RECORD OF TEMPORARY REVISIONS

SUPPLEMENT 106

HIGH INTENSITY STROBE LIGHT (HISL)

P/N 4G3340F03111

Figure S106-2 HISL Switches on Overhead Panel (Example)

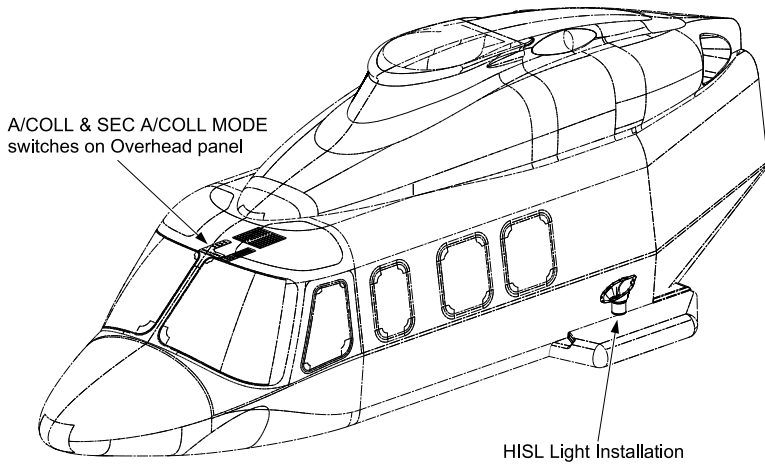
The selection of the HISL Light colour is using an additional switch on the Overhead panel SEC A/COLL MODE with the following selections:

- RED
- WHITE

Refer [Figure S106-2](#) for switch positions.

Figure S106-1 HISL LIGHT Installation

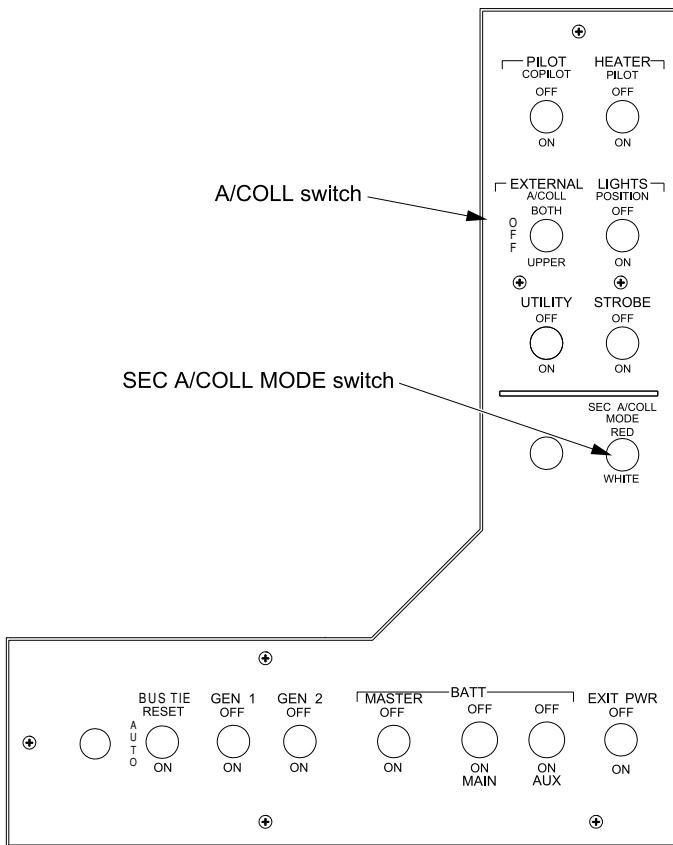
The High Intensity Strobe Light (HISL) installation configures the aircraft with a dual colour white/red strobe light under the belly of the aircraft ([Figure S106-1](#)) which is in addition to the standard red strobe light mounted on the top of the fin. The white HISL emits a light at an intensity of 2000 candela and is designed to increase the visibility of the helicopter in daylight conditions. The red light is of lower intensity.
